*Analysis and Report on Sections 2 and 3 of the Comments of the Keweenaw Bay
Indian Community (KBIC)—Final*

Prepared for the United States Environmental Protection Agency – Region 5

By The Cadmus Group, Inc. under contract # EP-C-08-015

March 2010

Figure 3. Bedrock faults, dike, and lineaments, and modeled FEFLOW fractures.

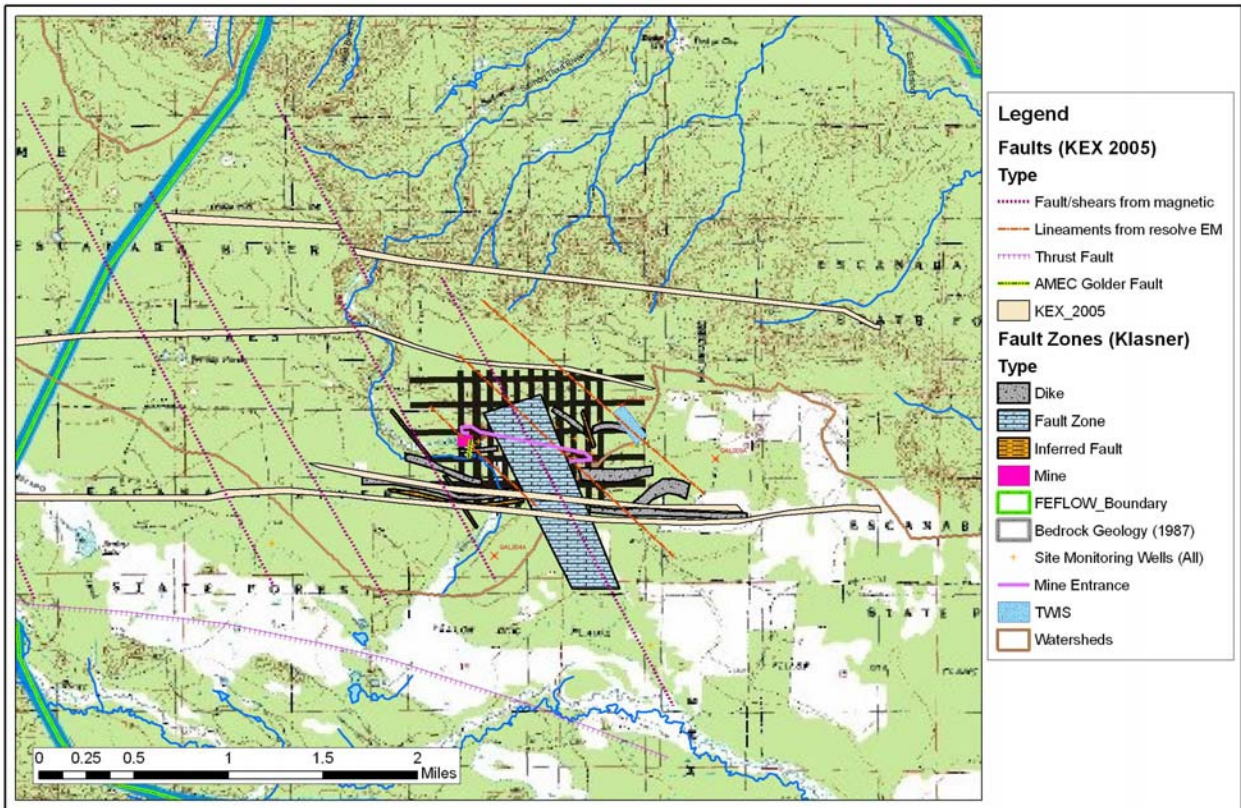
In Figure 3, a closer examination is presented, and the modeled vertical fractures included in the FEFLOW model are superimposed (Figure 5-3, Golder Associates, 2006b).

KEMC did include vertical fractures, but only in the lower bedrock. It is unclear why the fractures were not included in the upper bedrock. Cadmus finds that this assumption does not appear to be supported.¹⁶

Furthermore, these fractures were inferred as a uniform grid pattern spaced 120 and 226 meters apart. The KEMC report only describes hydraulic conductivity of the upper and lower bedrock without regard for vertical or horizontal components.¹⁷ The vertical fractures (water conductive features) are designated as having a transmissivity of $3 \times 10^{-6} \text{ m}^2/\text{s}$ in Figure 3-1 and a hydraulic conductivity of $3 \times 10^{-6} \text{ m/s}$ in Table 5.1, with a width of 1 meter. Assuming the hydraulic conductivity and width description to be correct, one can calculate an equivalent vertical hydraulic conductivity for a block 226 x 100 meters as $(226 + 120) * 1 * 3 \times 10^{-6} \text{ m/s} / (226 * 120) = 3.8 \times 10^{-8} \text{ m/s}$. This is 76 times greater than the bulk hydraulic conductivity of $5 \times 10^{-10} \text{ m/s}$. In other words, there is a 1:76 horizontal to vertical hydraulic conductivity ratio. Such a large ratio appears to be somewhat unreasonable in that the model offers significant vertical movement with little vertical head resistance than might be expected. This anisotropy is neither noted by KEMC, nor evaluated by KEMC as to its importance.

Figure 4a. Bedrock faults, dike, and lineaments. The mapped area is within the FEFLOW model area.

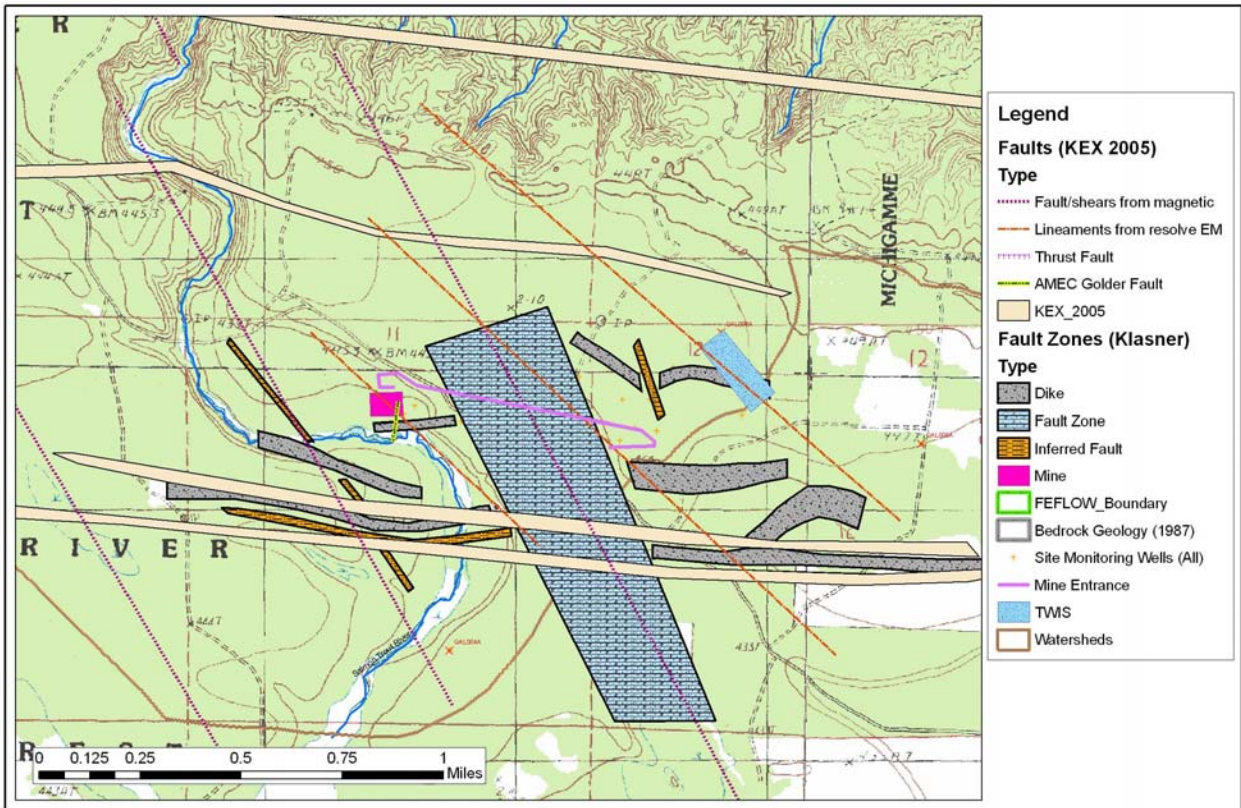
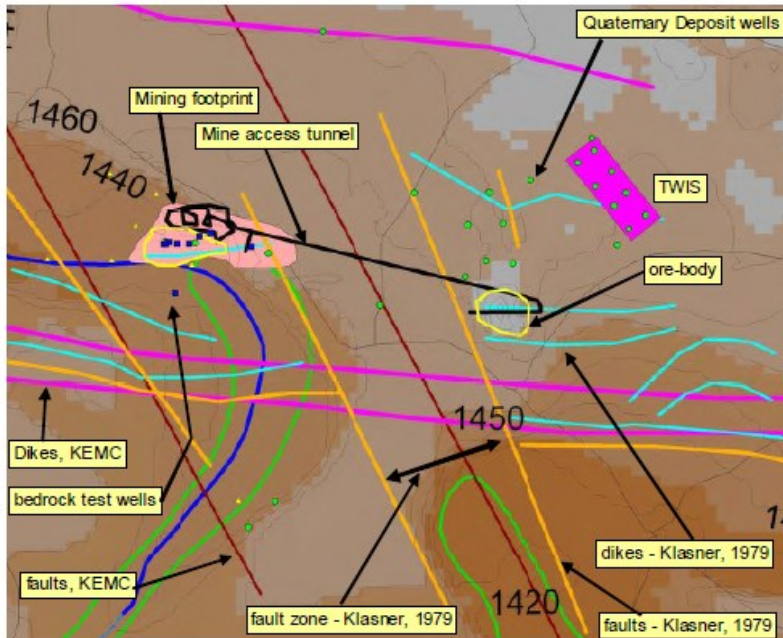
The region about 2 miles across the faults shown in Figure 4a is similar to that presented by KBIC (2009) (KBIC's Figure 2-1; Figure 4b below).

Figure 6. Site geology, and hydraulic heads predicted for when mining has ceased, using revised base case (Golder Associates, 2006b, Figure 9.2). The mapped area is within the FEFLOW model area.

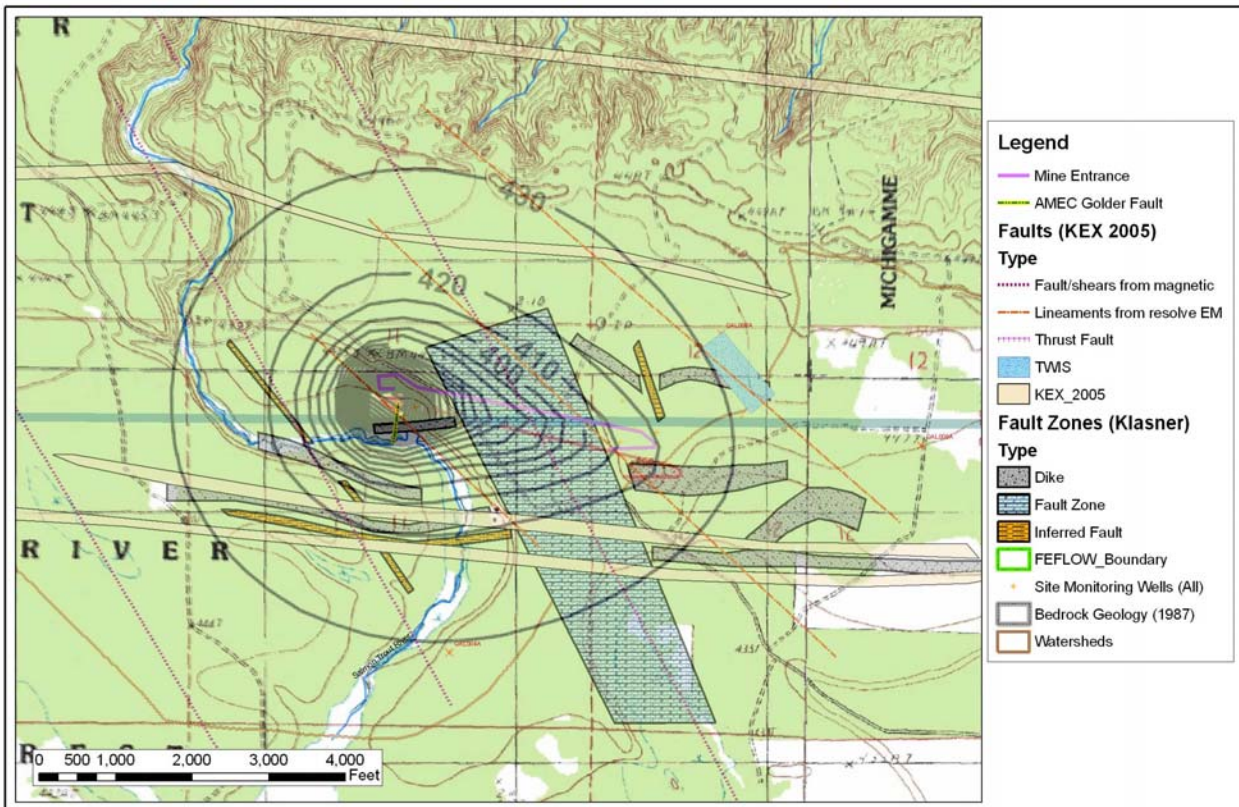
In Figure 6, the model predictions of hydraulic head (Golder Associates, 2006b, Figure 9-2) are shown. The modeled extent of the depressurization predictions is inconsistent with the presence of the fault, dikes, and lineaments. Dikes are typically very low permeability and one would not expect pressure changes to cross these features.¹⁴

The fault zone, dikes, and lineaments were essentially ignored in the characterization of the bedrock flow system used to develop the FEFLOW model.¹⁵ Cadmus finds that this is a major shortcoming in the ability of the model to accurately represent ground water flow patterns during

Figure 10. Predicted results for revised Base Case. The mapped area is within the FEFLOW model area.

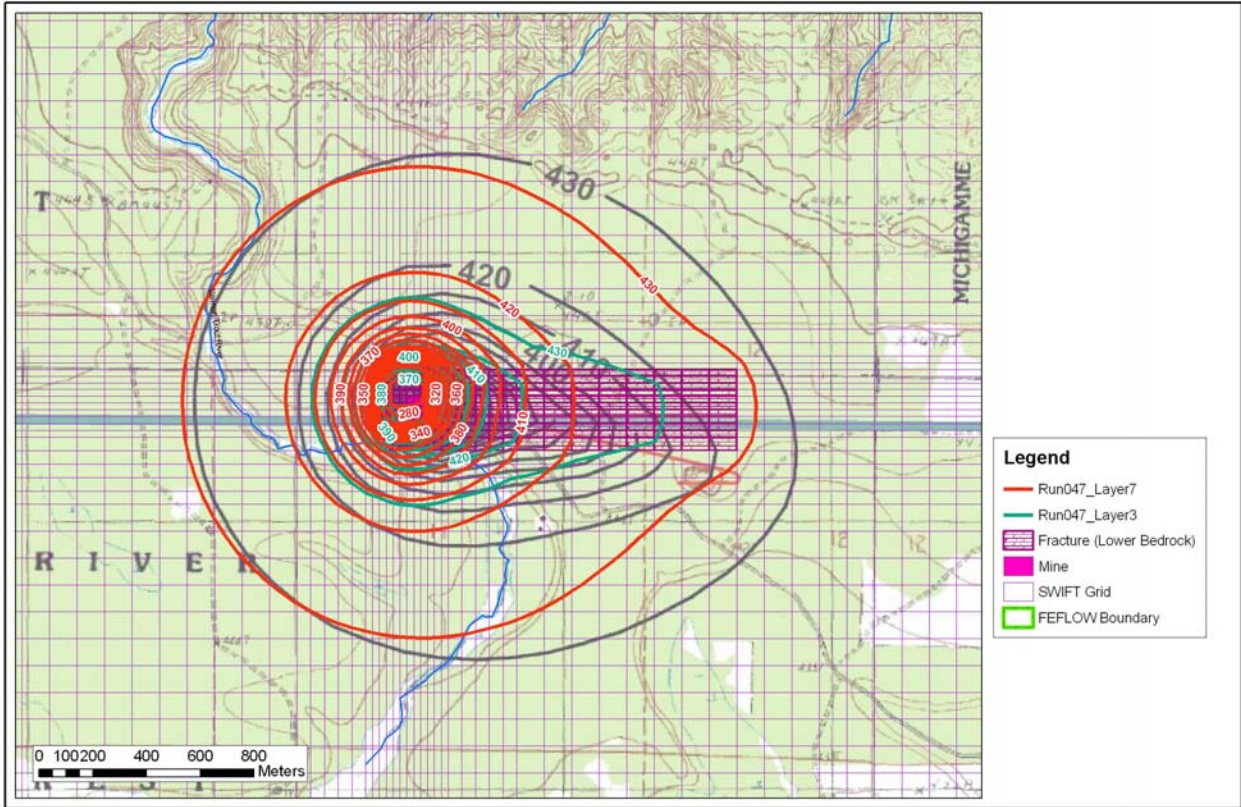
Results from Run 47, along with the predicted hydraulic heads from the revised base case (Golder Associates, 2006b, Figure 9.2) are shown in Figure 10. The SWIFT results are presented for layer 3 at the top of the lower bedrock and Layer 7 deeper into the mine level. In general, while not shown, the vertical distribution of predicted hydraulic heads displays a similar pattern with both models.

With respect to representation of the vertical fracture network, in light of the model differences, the results from SWIFT are similar to those from FEFLOW. This confirms that the modeling analyses by KEMC, Cadmus, and KBIC are comparable.

Figure 11. Predicted results for revised KBIC Scenario 6 (100x fault permeability). The mapped area is within the FEFLOW model area.

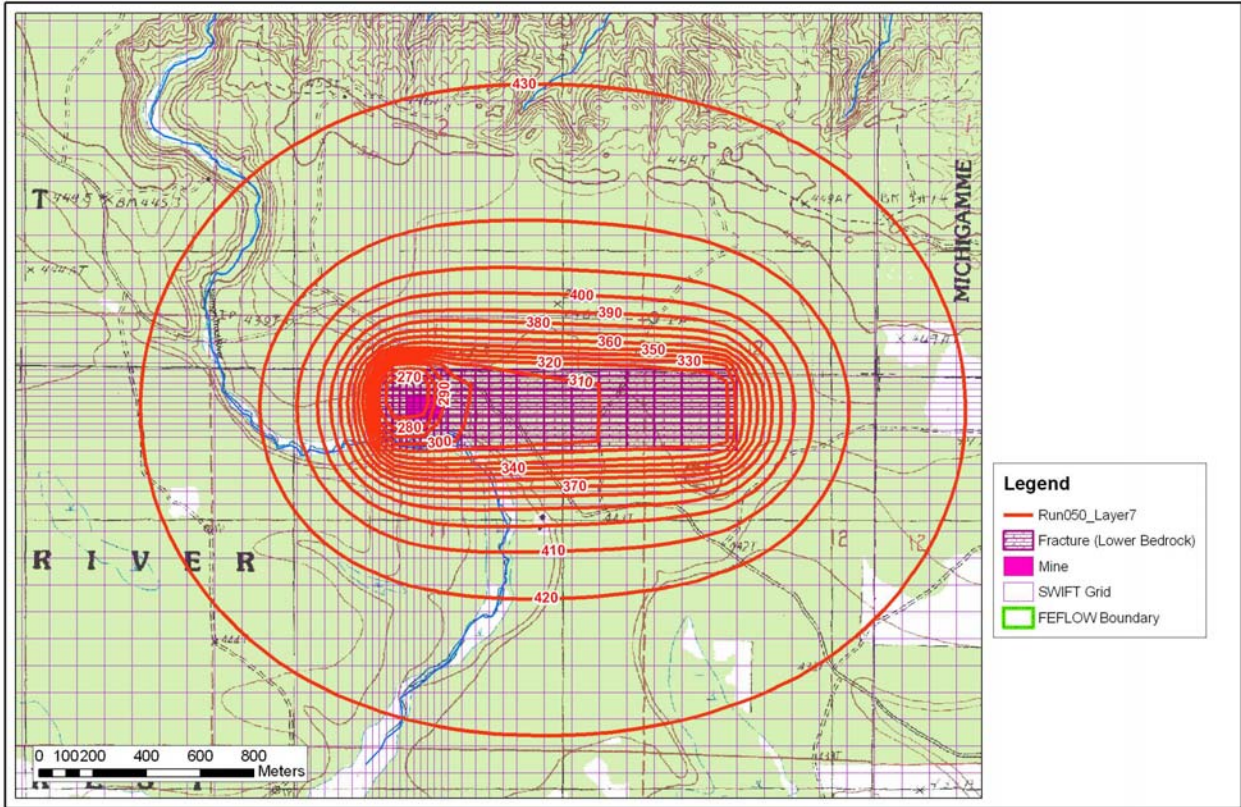
Because of uncertainty in the hydrogeologic characterization, it is reasonable to conduct simulations with variations in the fracture permeability. This is not the same as a true uncertainty analysis, but does provide insight regarding how the system responds to the unknown variability of localized fractures in the lower bedrock. A rigorous uncertainty analysis would provide quantitative statistics resulting from parameter uncertainty (Hill and Tiedeman, 2007). In Figure 11, the predicted hydraulic heads for KBIC Scenario 6, wherein the vertical conductivity is increased by a factor of 100, are shown. The more regular contours in Figure 11 are a reasonable result. Note that the extent of the depressurization increased slightly whereas the rate of mine inflow increased by a factor of over 50.

Figure 12. Predicted results including hypothesized no-flow dikes. The mapped area is within the FEFLOW model area.

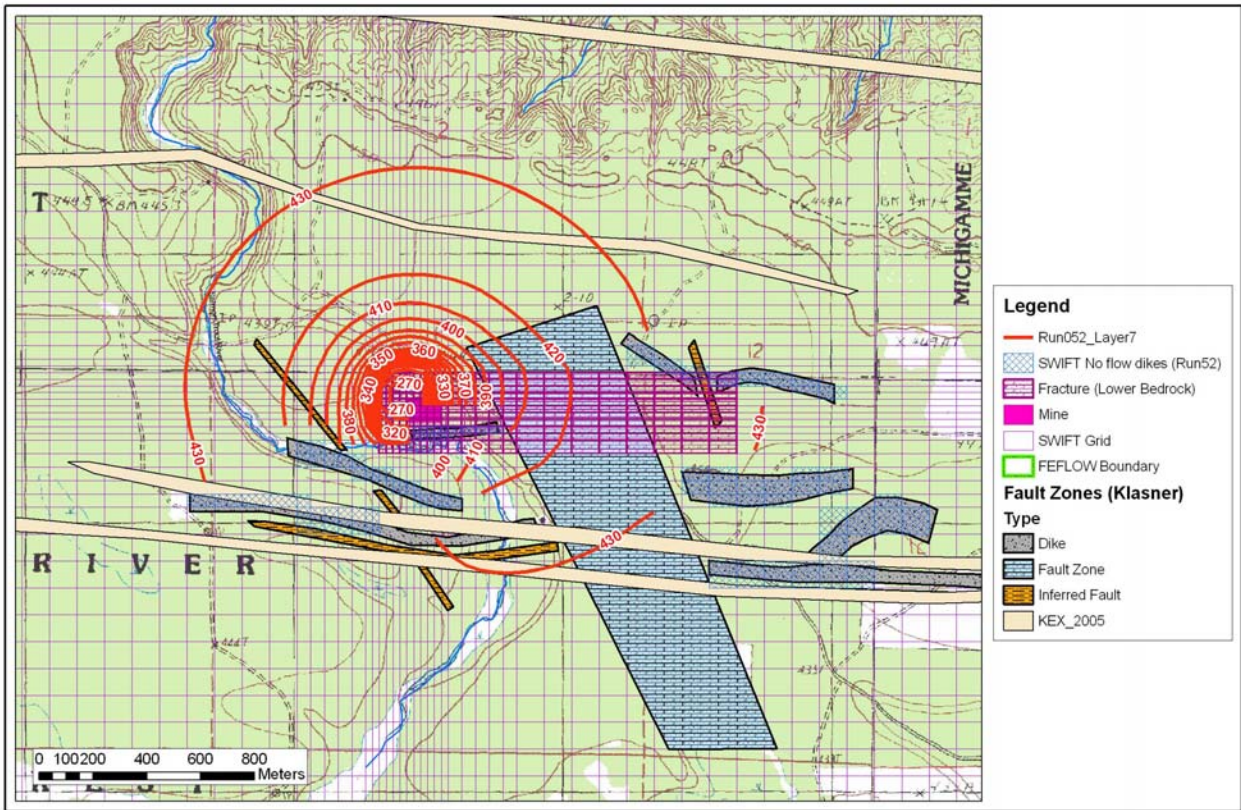
Given the uncertainty of the geologic characterization, an evaluation simulation (Run 52) was conducted in which the dikes as presented by Klasner et al. (1979) were included. For simplicity, the dikes were represented as no-flow cells that are completely impermeable. In Figure 12, the predicted equipotential lines are interrupted by the dikes. The contours are discontinuous because the no-flow cells representing the dikes in SWIFT are inactive cells. (Note that these inactive cells are represented as blue cross-hatched areas labeled "SWIFT No flow dikes (Run52)" in Figure 12.) The small gaps are due to the interpolation technique, in which contour lines are stopped prematurely within the active cells and cannot be extended to the inactive cells. Overall,

the extent of the depressurization is similar to the base case (Run 47), as shown in Figure 10. Thus, the absence of the dikes in KEMC’s model is a reasonable simplification.²⁰
